**AMENDMENTS TO THE DRAWINGS**

Attached hereto are replacement figure sheets for Figures 4 and 5, which include the changes, without markings, identified below.

FIG.5

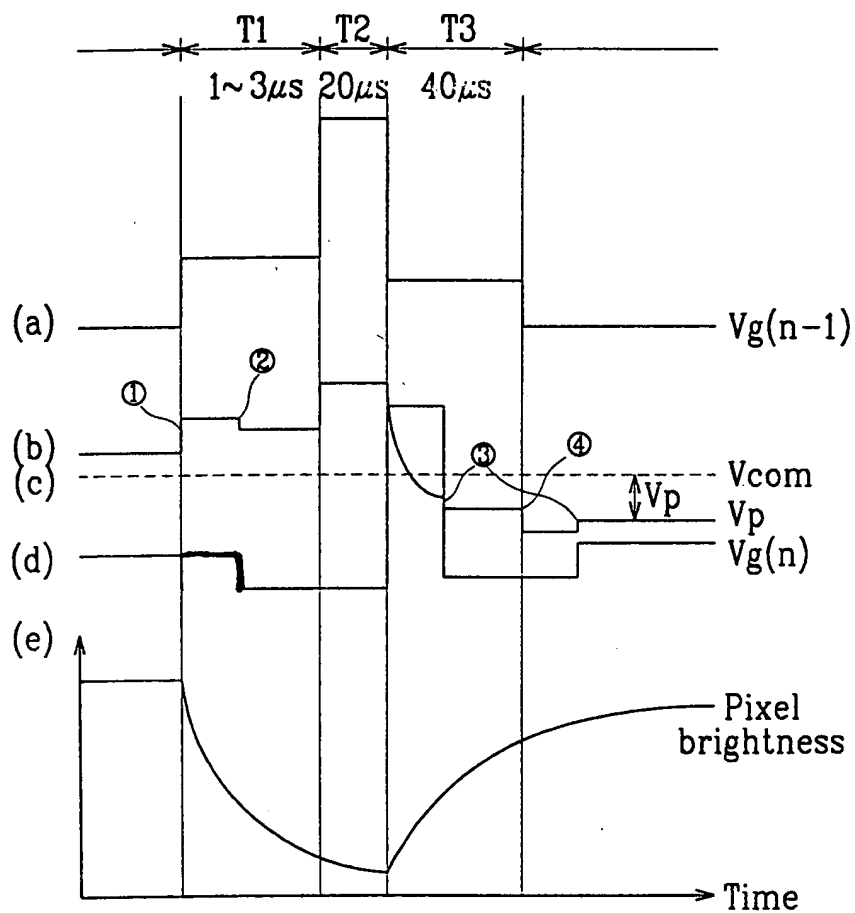
Figure 5 has been amended to correctly depict the delay between the beginning of reset interval T1 of  $V_{g(n-1)}$  which is identified as signal line (a) and the beginning of reset interval T1 of  $V_{g(n-1)}$ , which is identified as signal line (d). Applicant submits that support for the amendment can be at least be found in Figures 7A and 7B of Applicant’s original specification.
